14 October 2022

Document No.: TR-RPT-0003  
Revision: 02

Royal Far West  
14-18 Wentworth Street  
Manly NSW 2094

**RE: Royal Far West Redevelopment, Manly – Transport Assessment Addendum**

**Figure 1: Proposed ground floor plan**

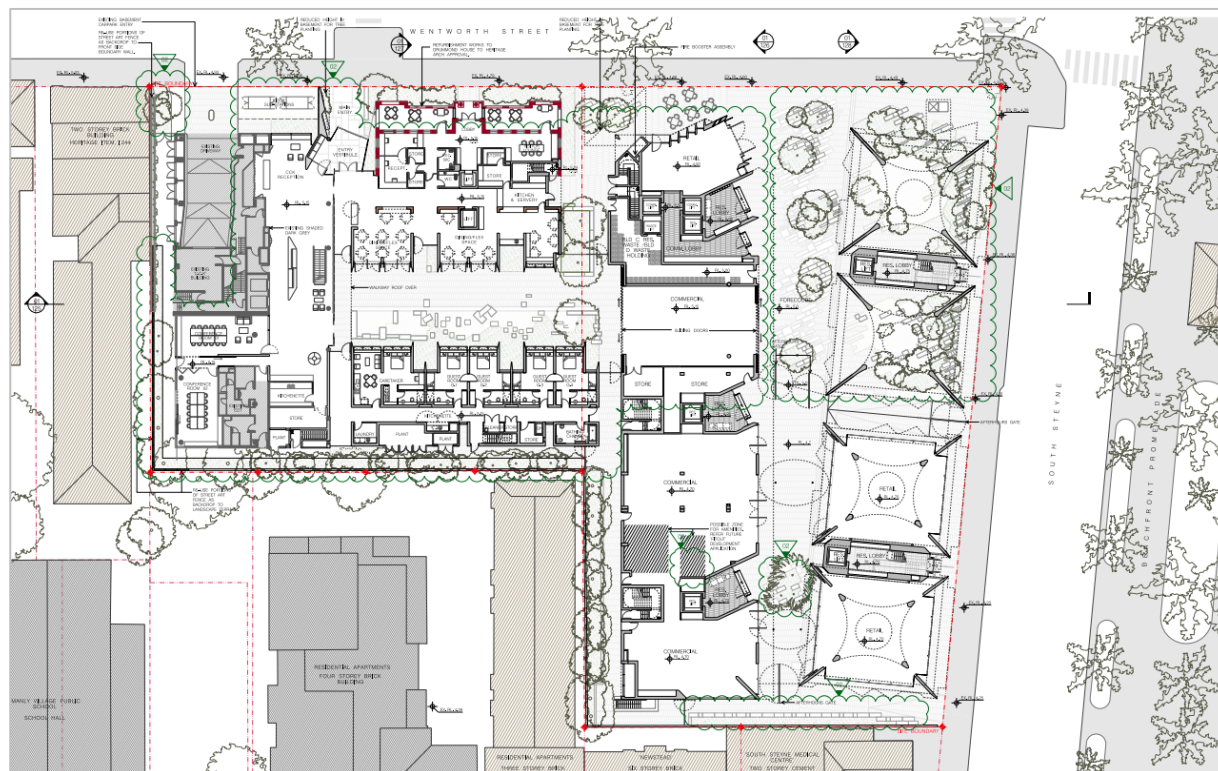
Furthermore, residential waste collection is no longer to occur within the basement, with waste collection to be undertaken by Council and occur kerbside along Wentworth Street. Waste collection for the retail and commercial uses is proposed to remain within the basement.

A comparison of the development schedule associated with the previous and the current scheme is summarised in Table 1, with the proposed ground floor plan shown in Figure 1.
